CITY PLAN COMMISSION STAFF REPORT

Project Name
Mullins Corner

CD-CPC-2023-00105
Development Plan – Non-Residential

Mullins Corner Development Plan Guidelines

BUILDING ELEVATIONS

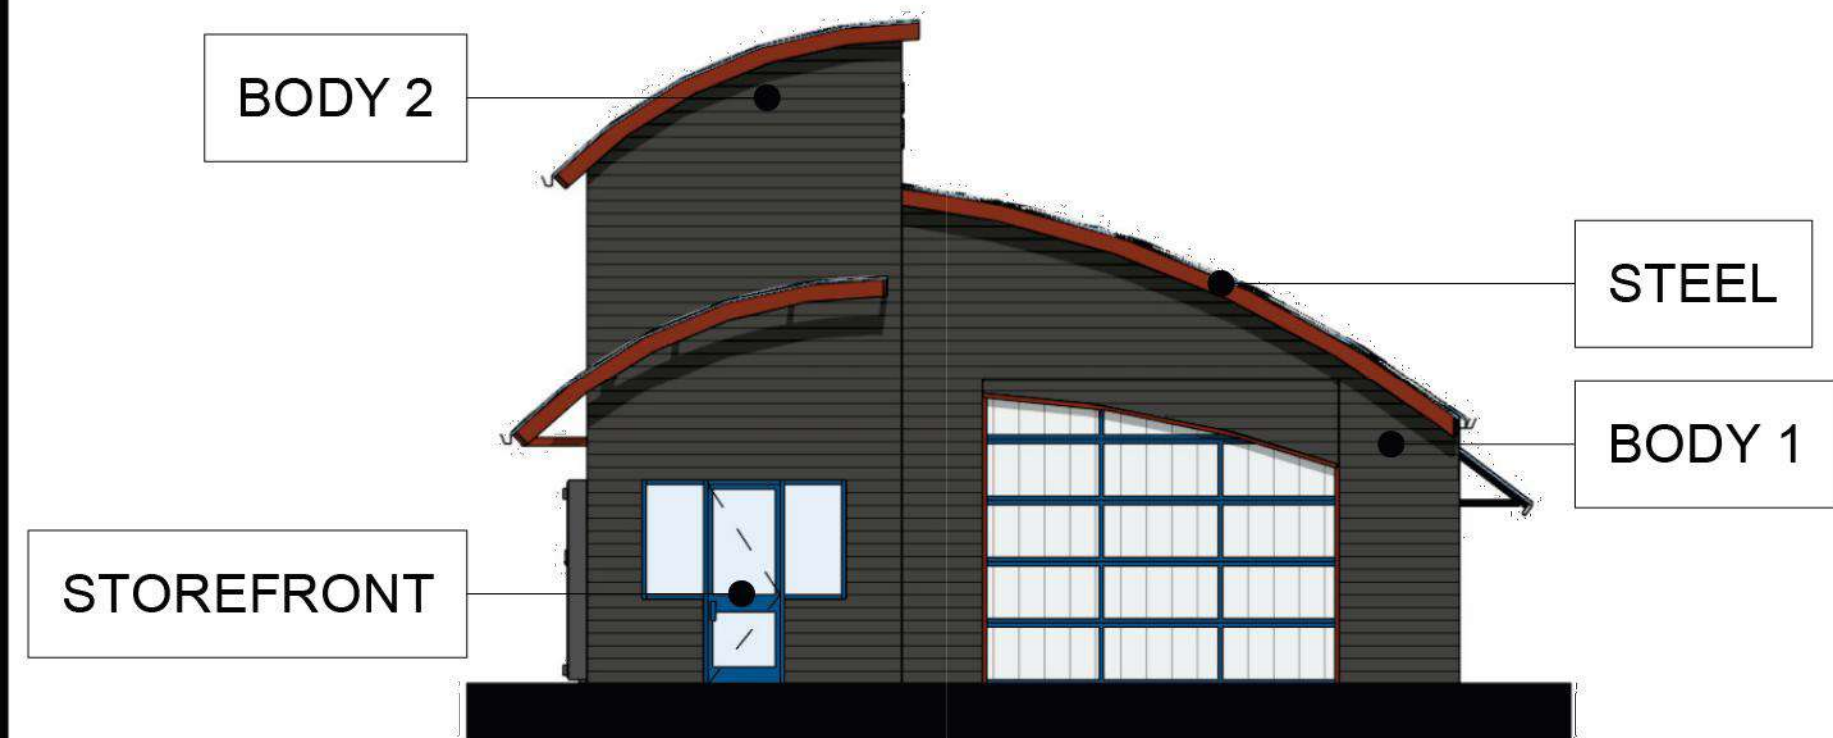
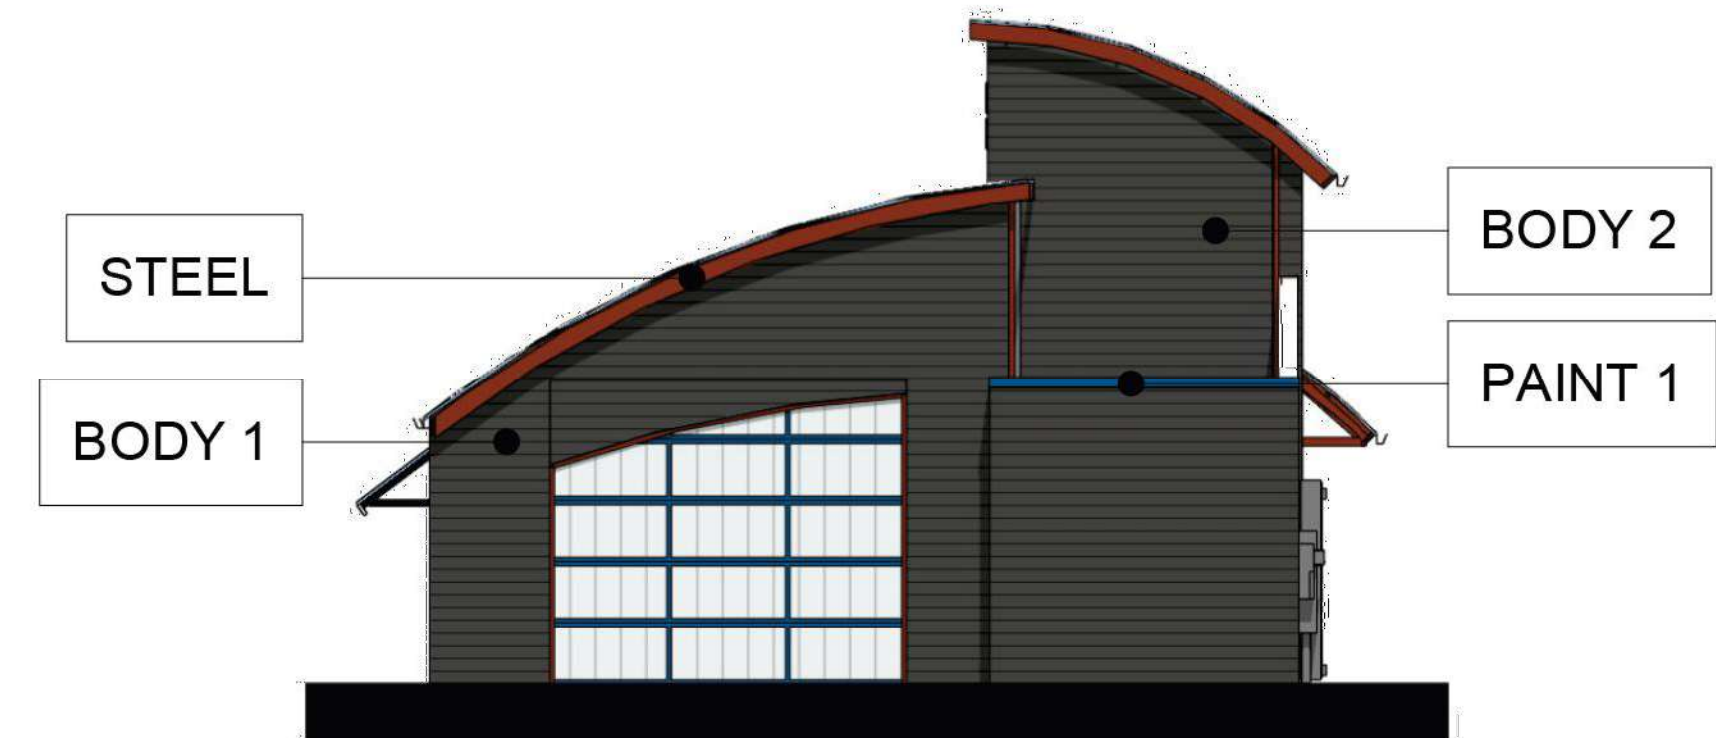
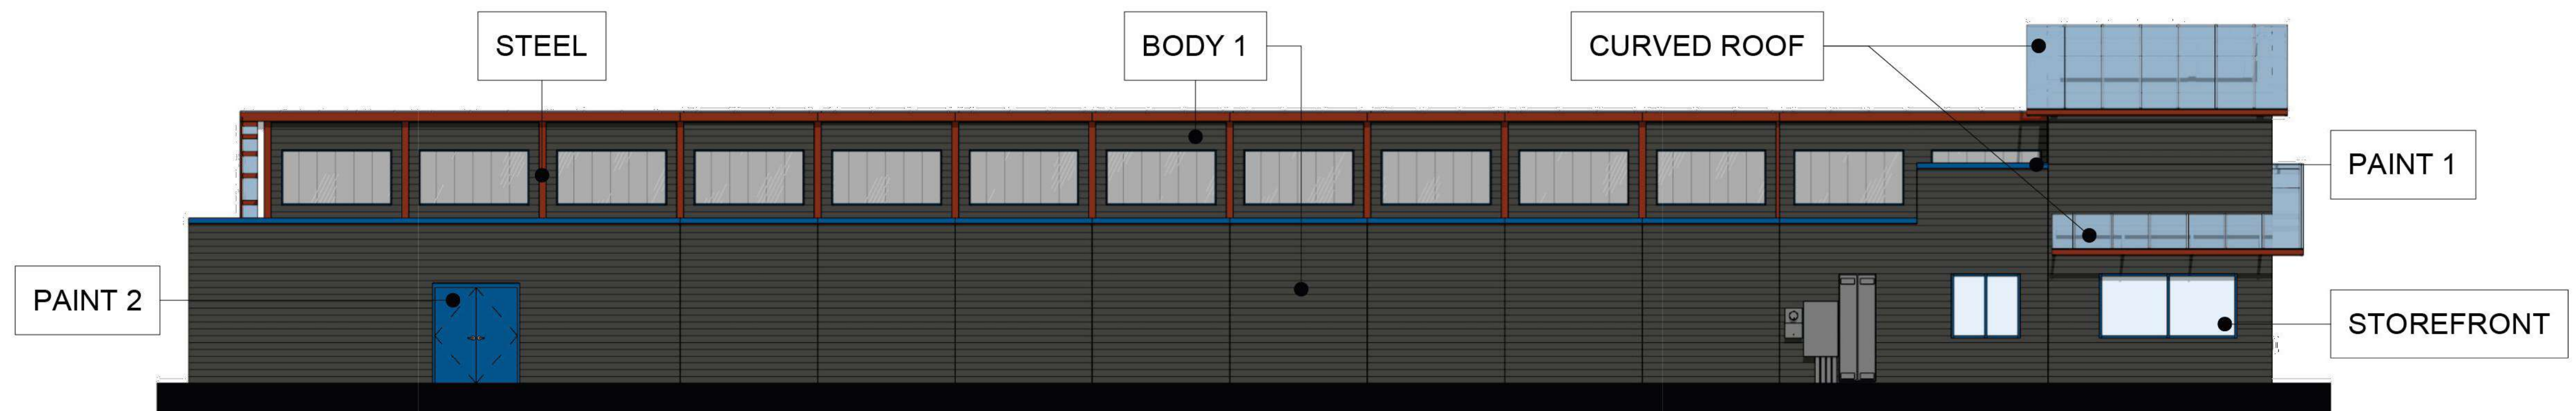
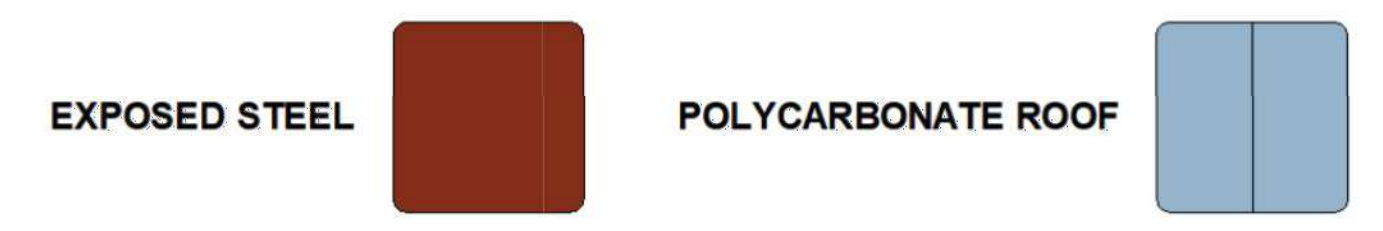
Proposed building materials for the carwash include stucco and metal panel for the majority of the building. The roof will be polycarbonate. Staff has added a condition for the applicant to continue working with the City to revise the proposed elevations prior to building permit to better reflect what is written in the design guidelines attached to this case. Landscaping for lot 4B will be reviewed at the time of building permit.

The proposed design guidelines call out the use of building materials including brick, cast stone, stucco, and enhanced concrete panels that have the appearance of brick. One condition to this project dictates that the applicant continues to work with staff on the architectural design of the carwash building, as there is a large blank area on the rear façade.

10. The developer shall continue working with staff to revise building elevations for lots 4B to incorporate more of the high quality building materials listed in the design guidelines and label cardinal directions on front and rear facades prior to building permit.
